PROJECT COMMENTS

DATE: 3/25/2021

PROJECT NUMBER: SP2021-008
PROJECT NAME: Site Plan for Rockwall Friendship Baptist Church
SITE ADDRESS/LOCATIONS: 5645 STATE HIGHWAY 276, ROCKWALL, 75032

Seal
Revisions
Issue Date
18 March 2021
Sheet Name
LANDSCAPE PLAN
Sheet Number
L1.1

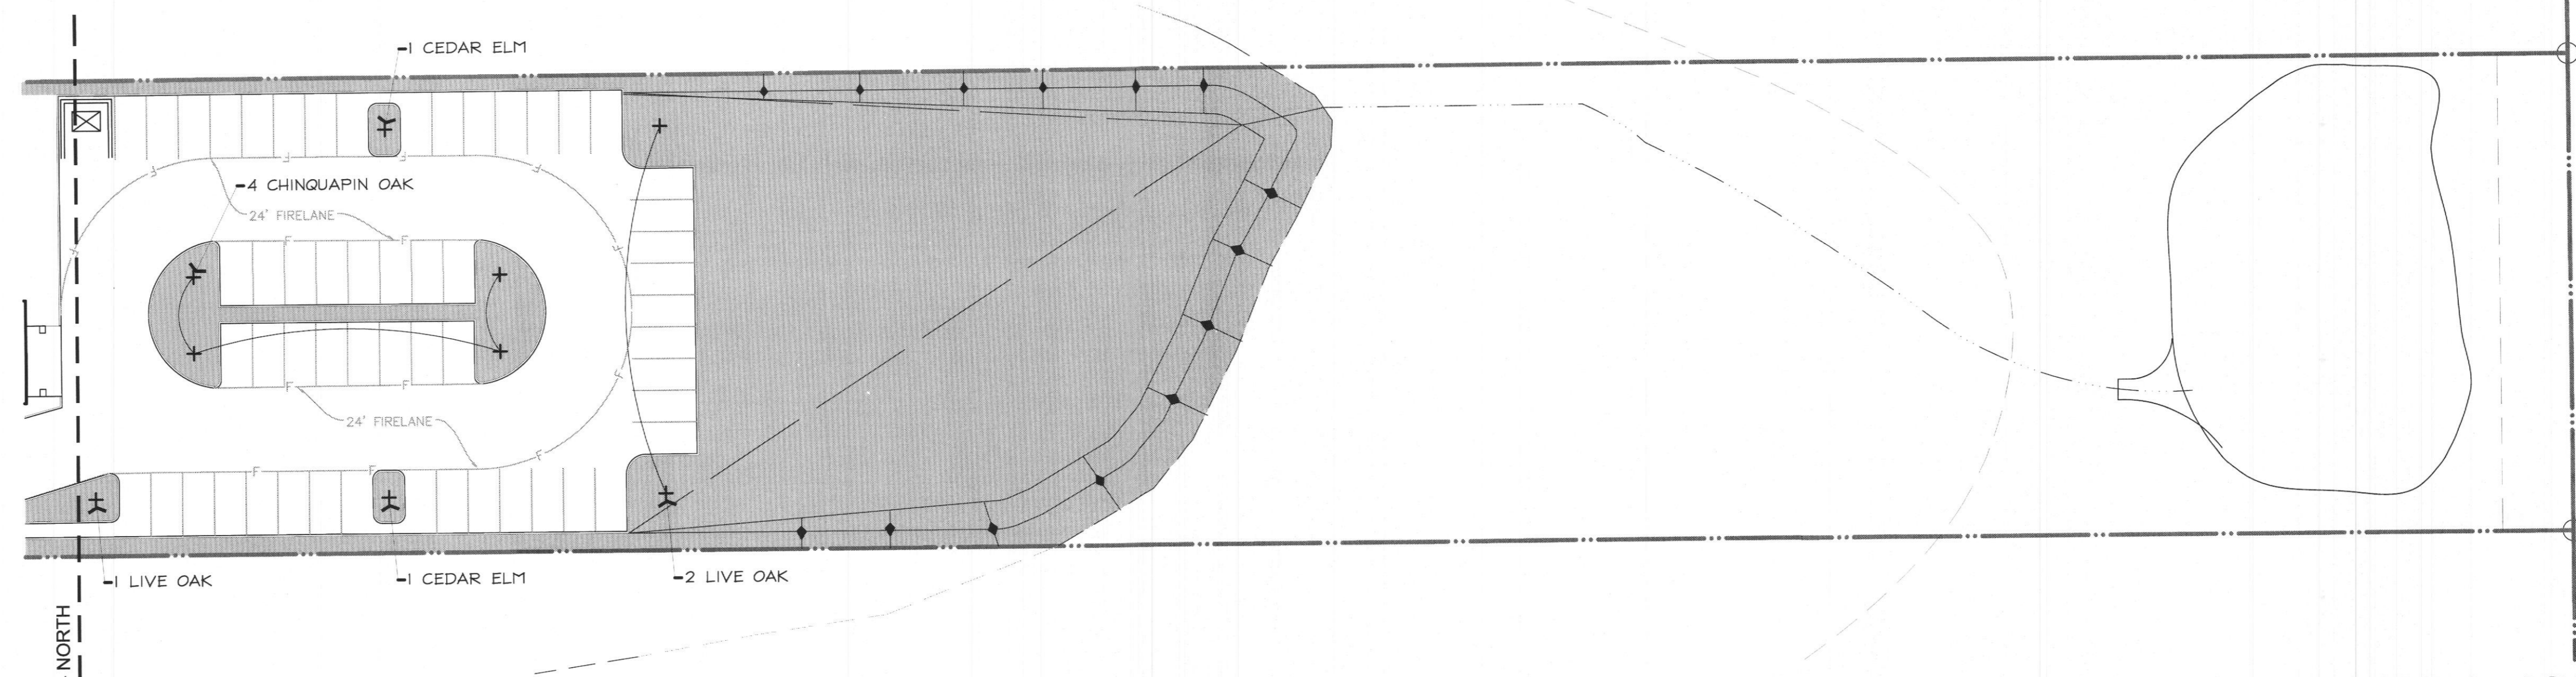
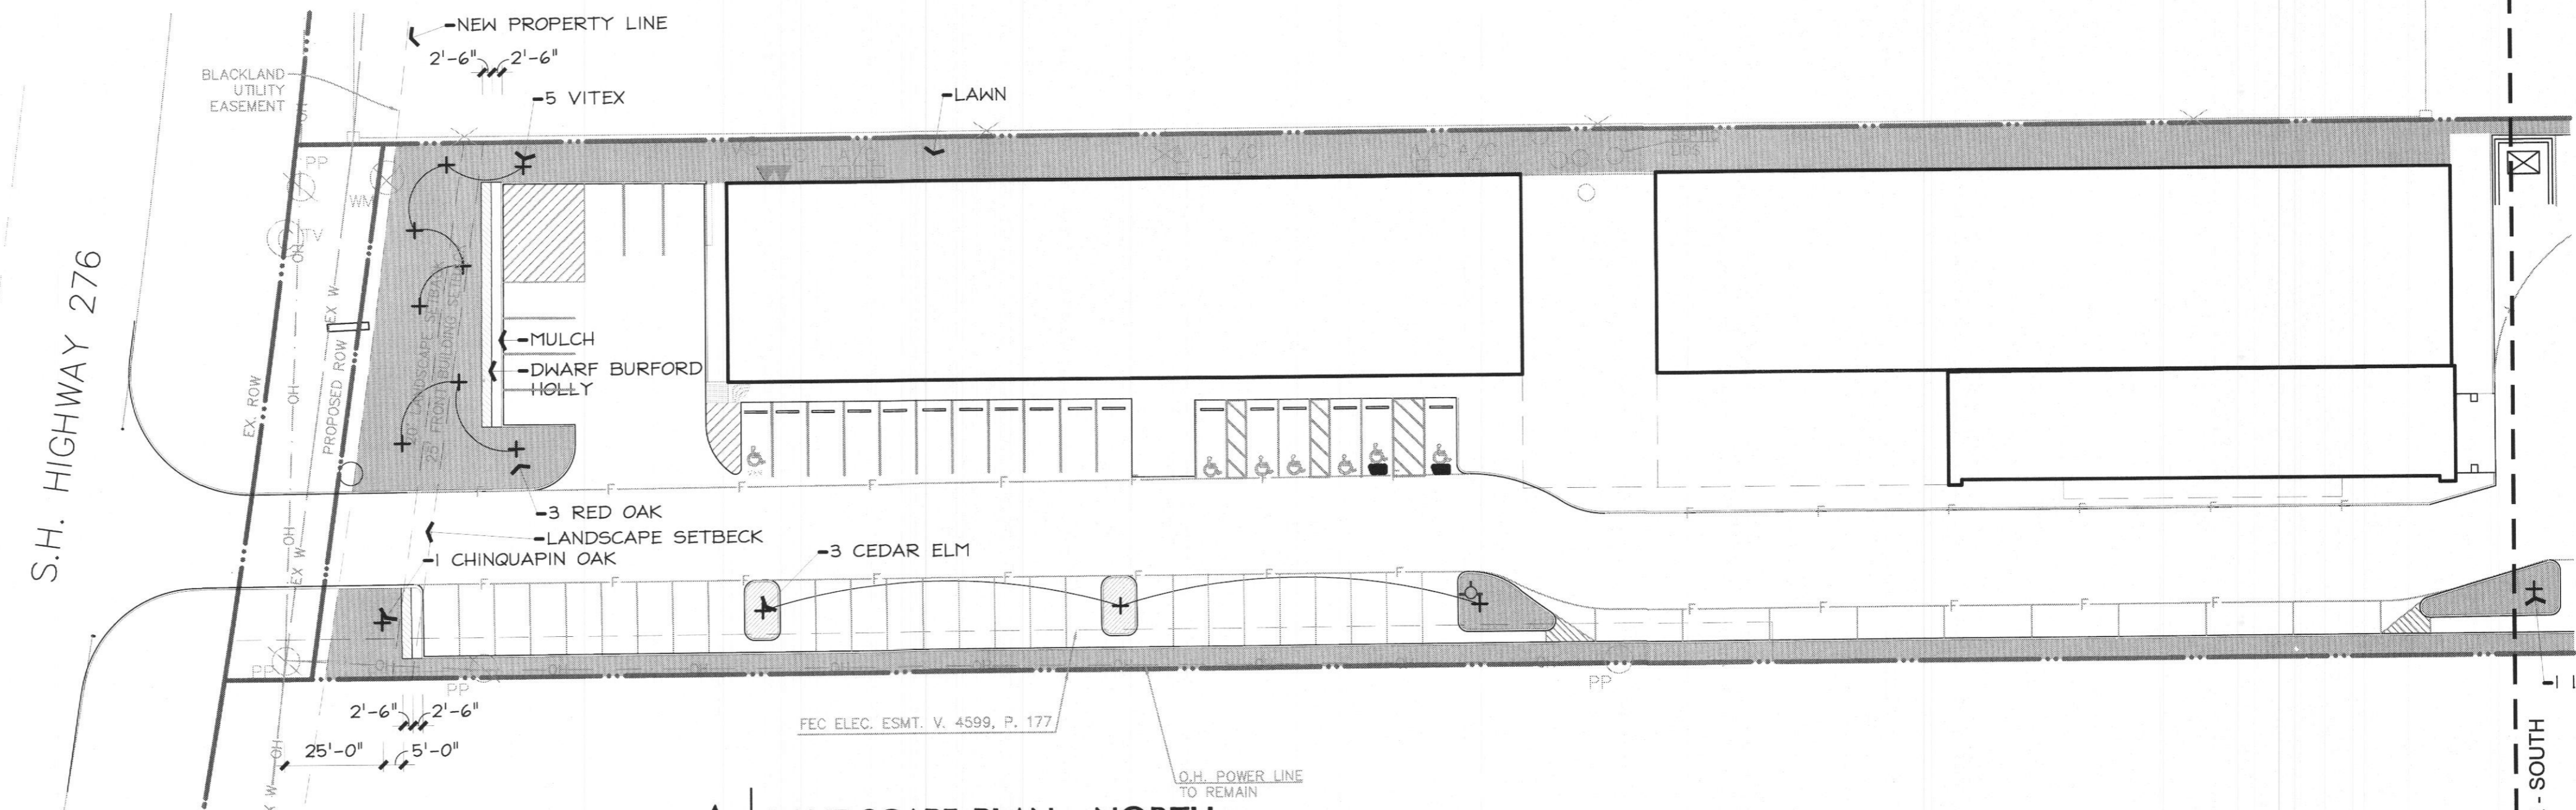
1. Provide the same site data information required in Section 2.1 Site Plan: Miscellaneous and Density and Dimensional Requirements of this checklist. Also verify the parking data between the site plan and landscape plan, and correct the zoning classification. (Section 2.1 of this checklist)

2. Include the quantity of trees and shrubs to be planted in the landscape table. Also canopy trees must be 4" caliper and shrubs are a 5-gallon minimum. (Subsection 05.03. B, of Art. 08)

3. All parking spaces are to be within 80ft of a canopy tree. Not all of the parallel parking spaces meet this requirement. (Subsection 05.03. E. 4, of Art. 08)

4. Identify visibility triangles on all lots for all driveway intersections and public streets. (Subsection 01.08, of Article 05)
5. The developer shall establish grass and maintain the seeded area, including watering, until a "Permanent Stand of Grass" is obtained at which time the project will be accepted by the City. A "Stand of Grass" shall consist of 75% to 80% coverage and a minimum of one-inch (1") in height as determined by the City. The South-East side of the property does not show any grass, please indicate what is to be done. (Sec. 4.2, Coverage, Engr Standards of Design and Construction)

**ELECTRICAL SITE
 PHOTOMETRIC
 PLAN**

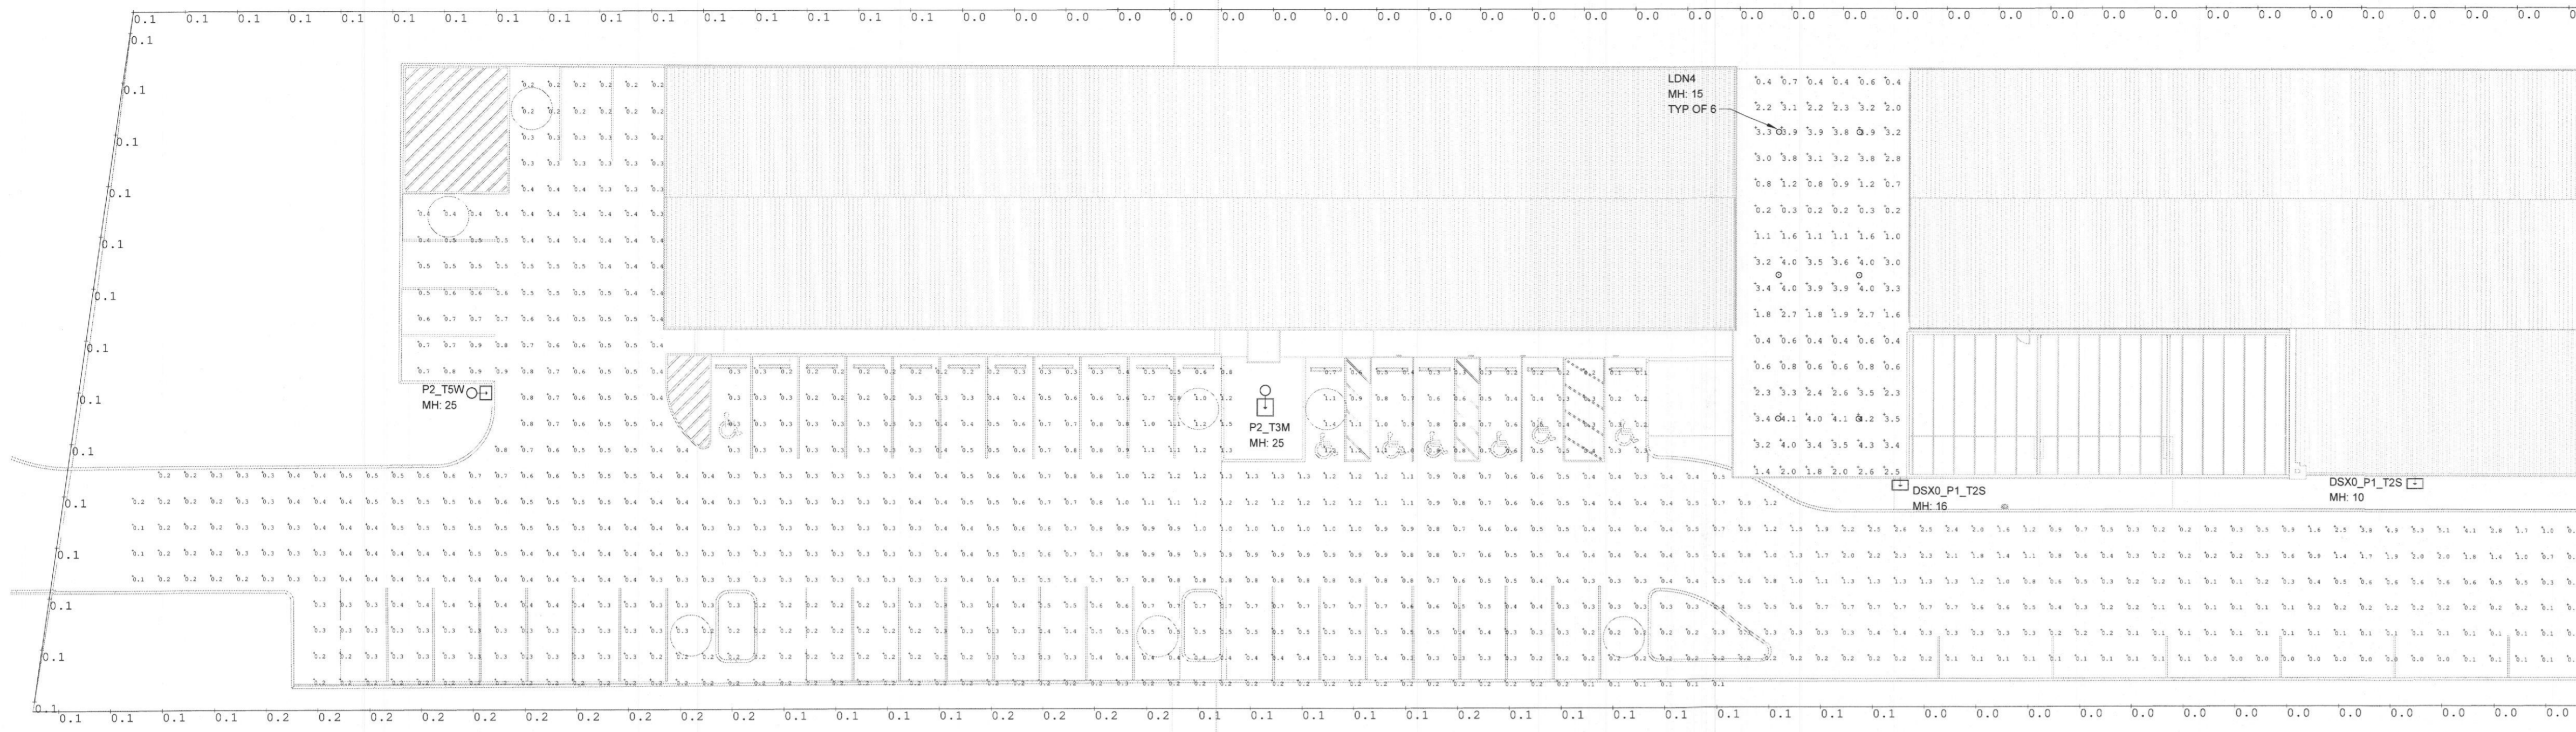
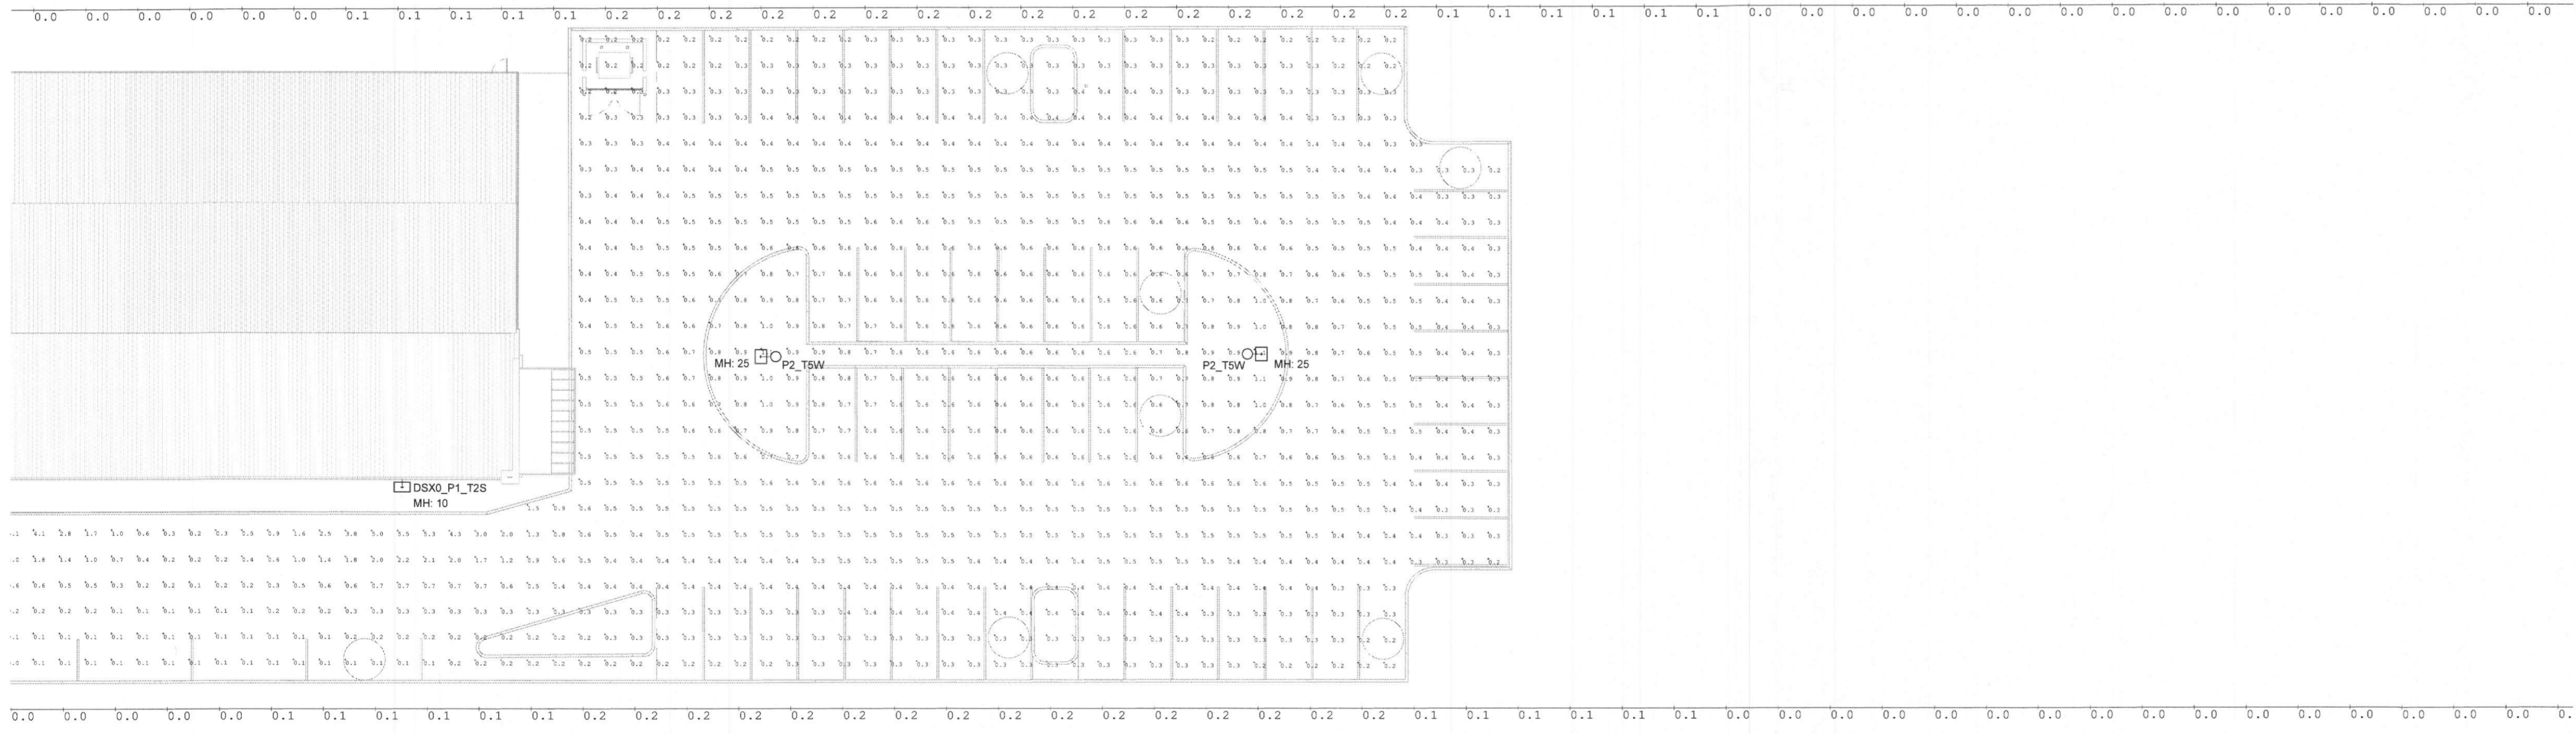
1. Provide the same site data information required in Section 2.1 Site Plan: Miscellaneous and Density and Dimensional Requirements of this checklist. (Section 2.1 of this checklist)

2. If there is up-lighting it cannot exceed 15 watts. (Subsection 03.03. A, of Article 07)

3. Provide elevation drawings or cut-sheets of proposed light fixtures. (Subsection 03.03, of Article 07)
